Donnybrook-Woodstock Infrastructure Contributions Plan

Part A (Part 2) Submission

Amendment GC102 to the Whittlesea and Mitchell Planning Schemes

October 2019

EXHIBITED ICP
(AUG 2018)

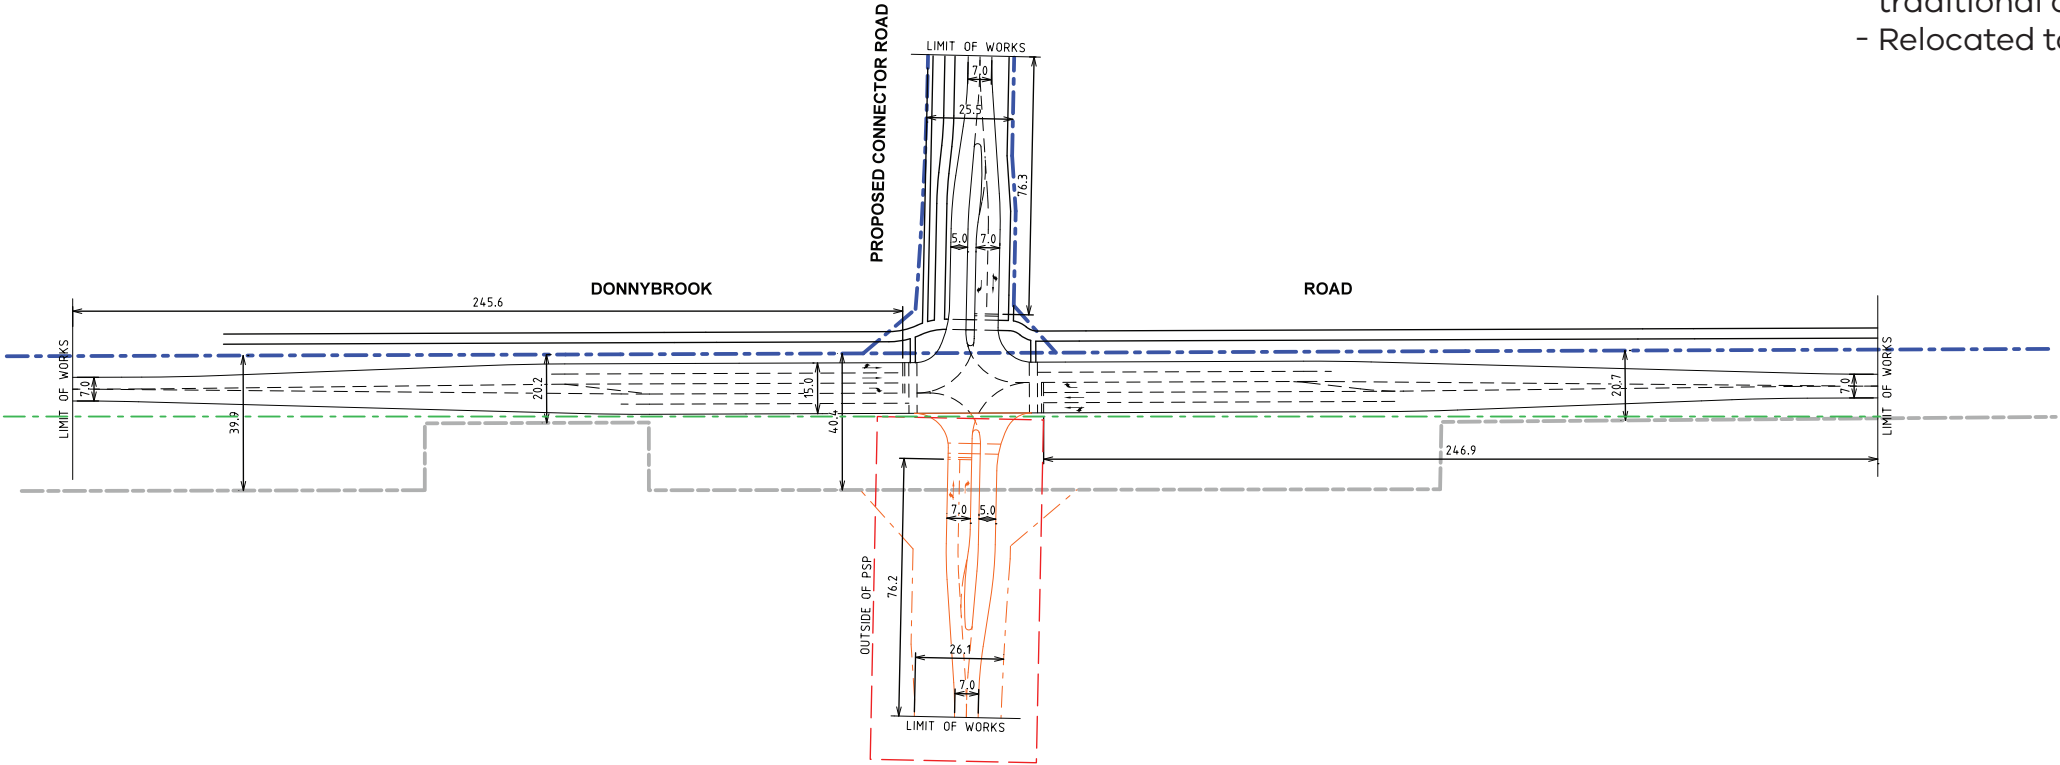
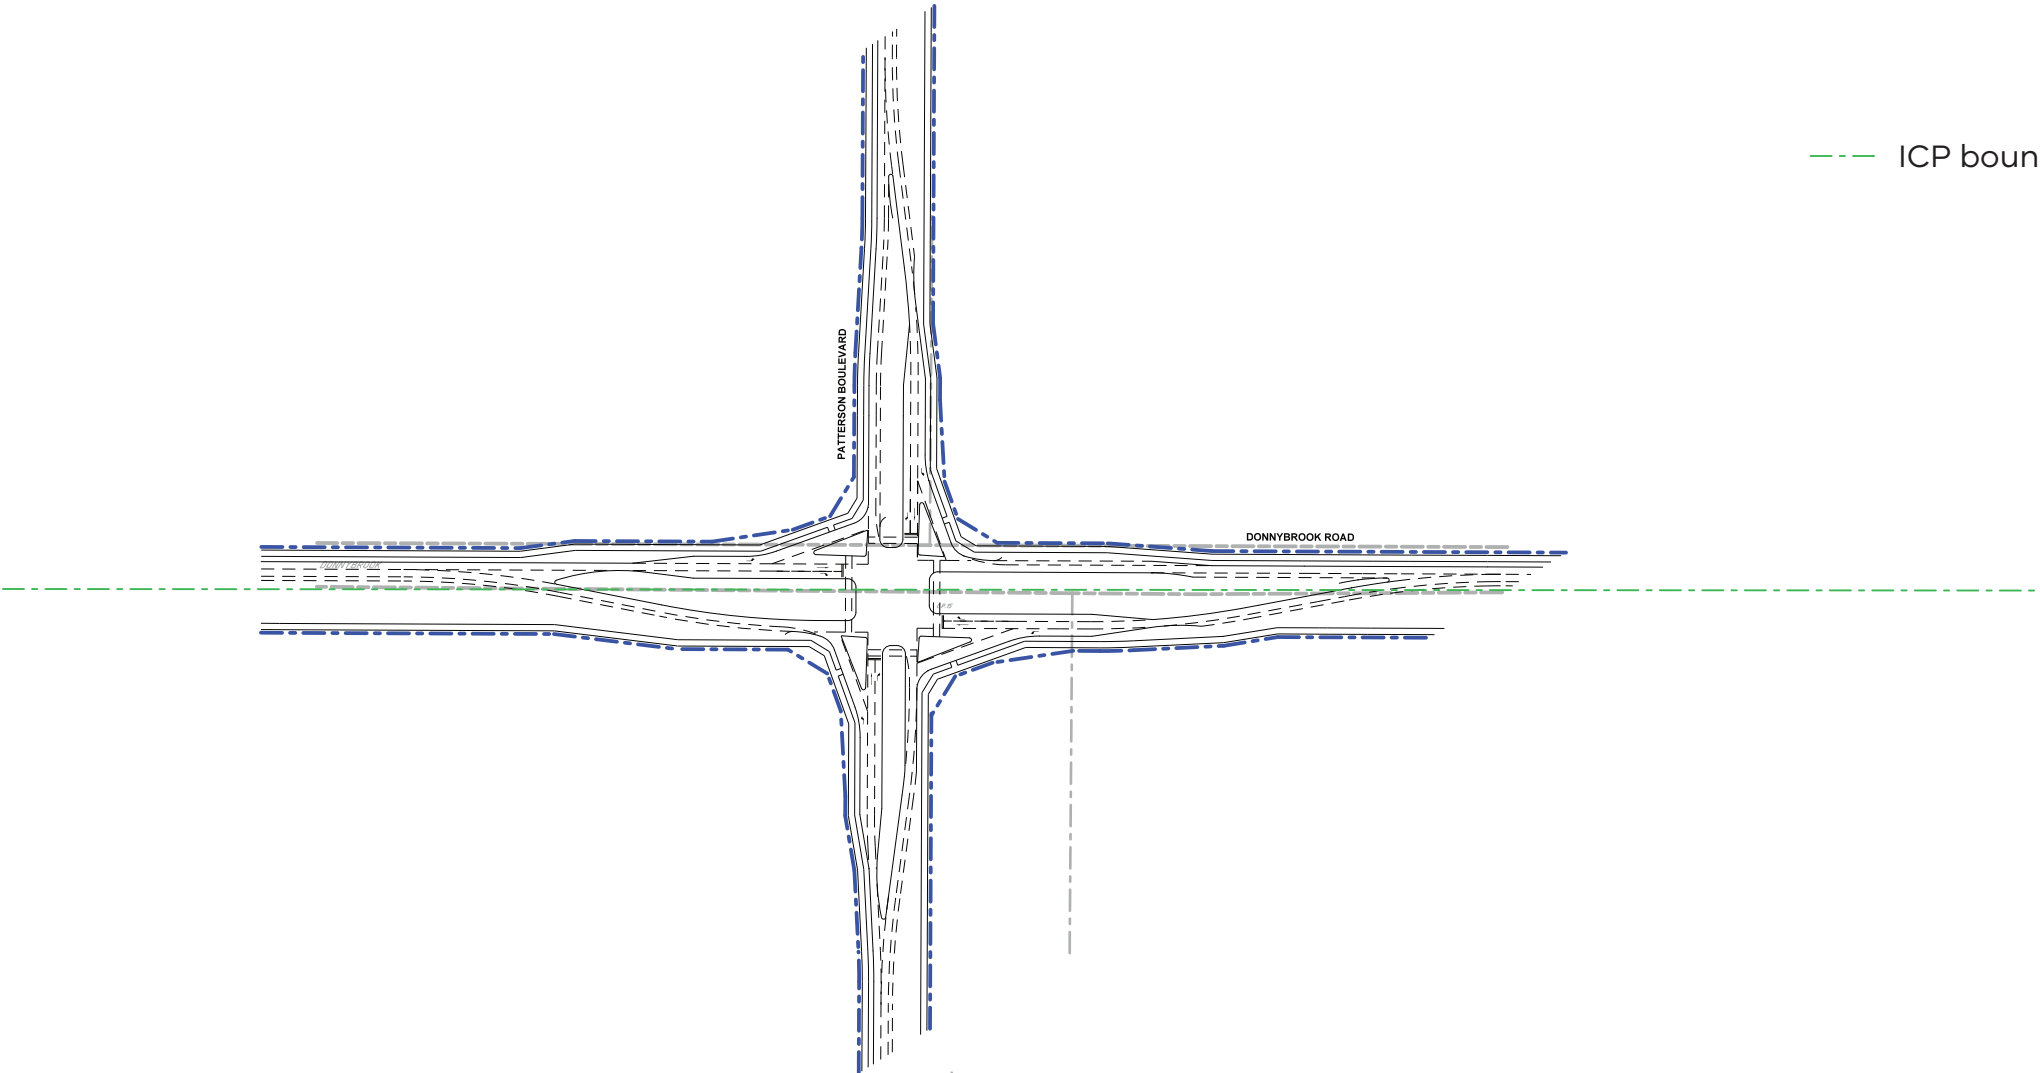
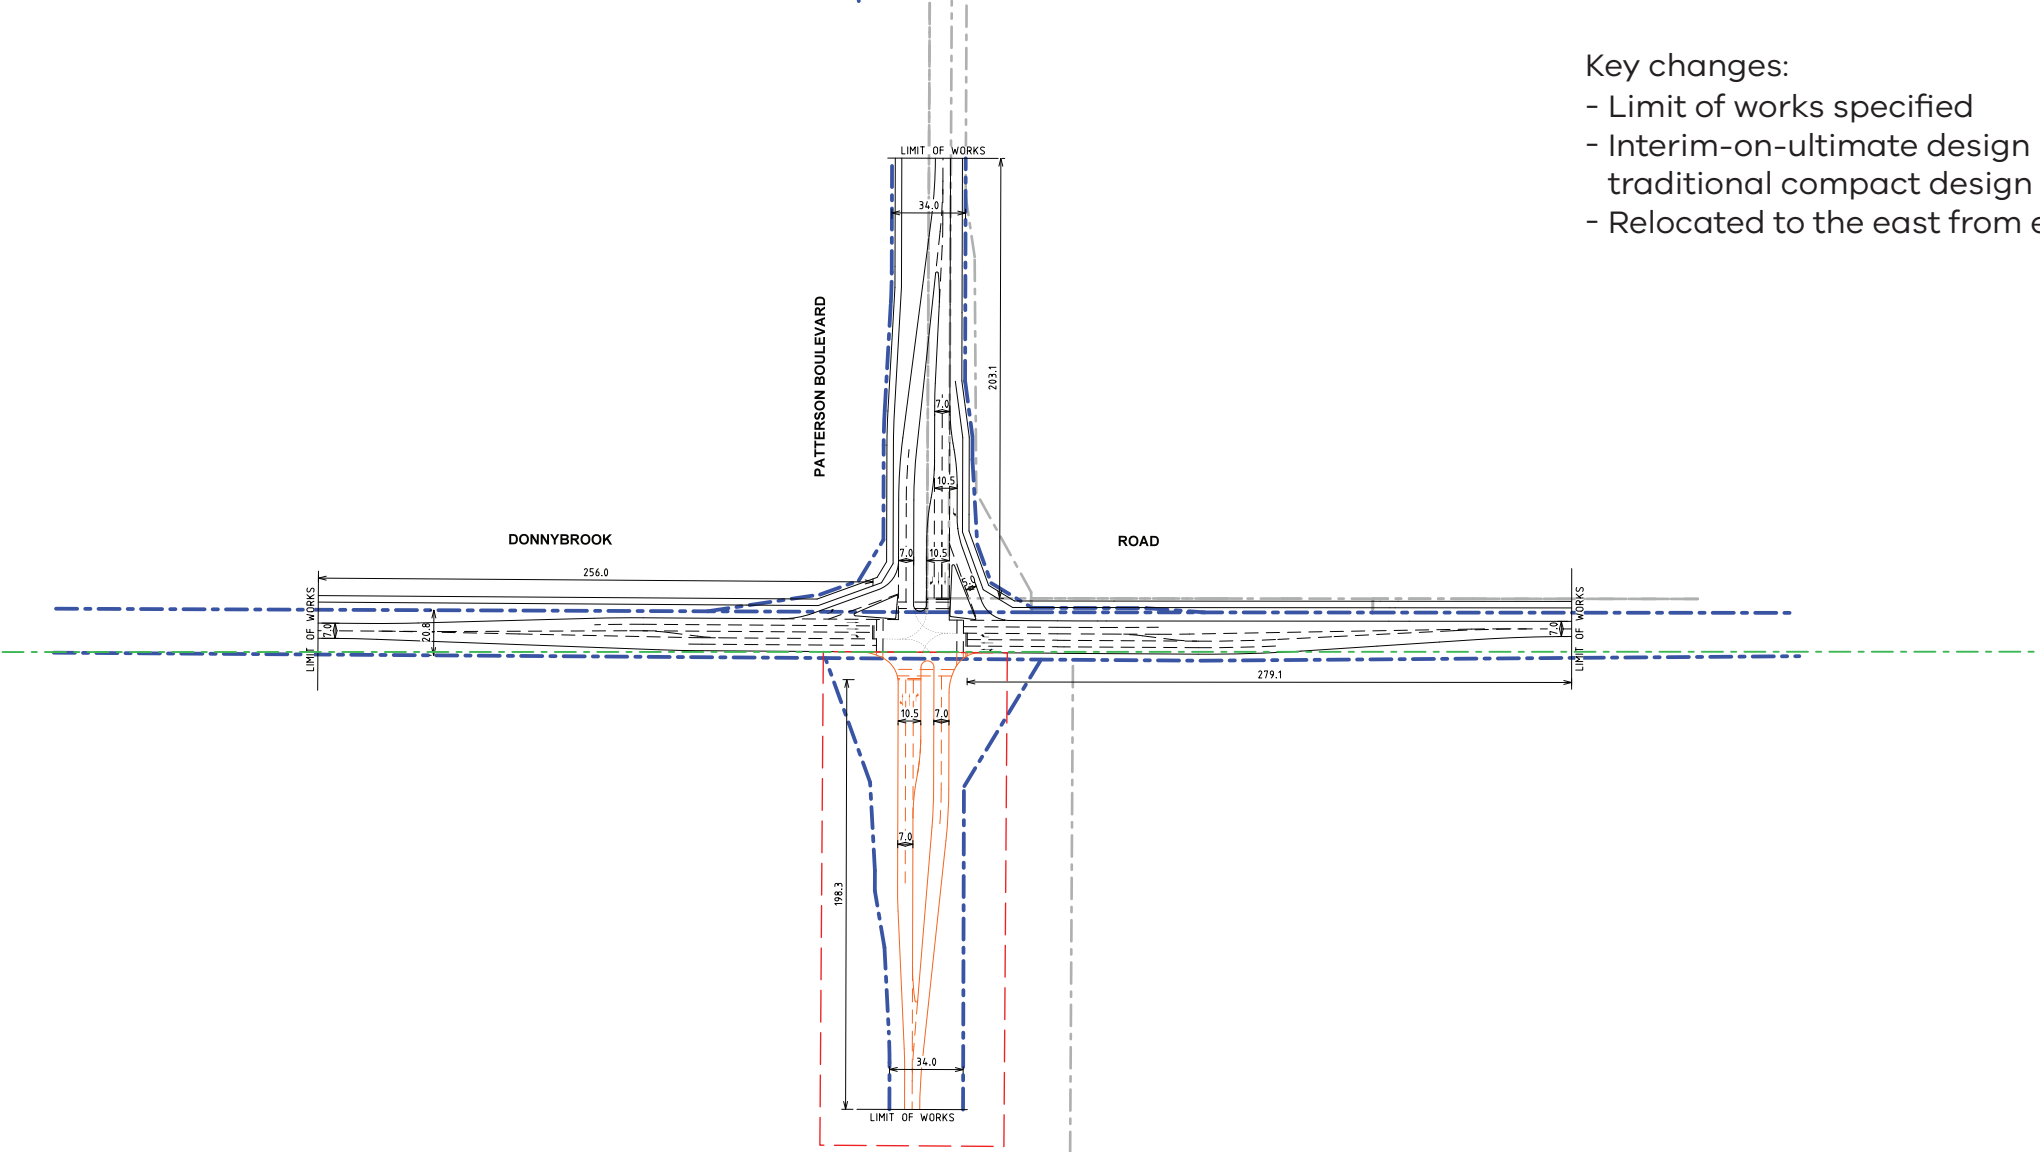
- Key changes:
- Limit of works specified
 - Interim-on-ultimate design replaced by traditional compact design
 - Relocated to the east from exhibited position
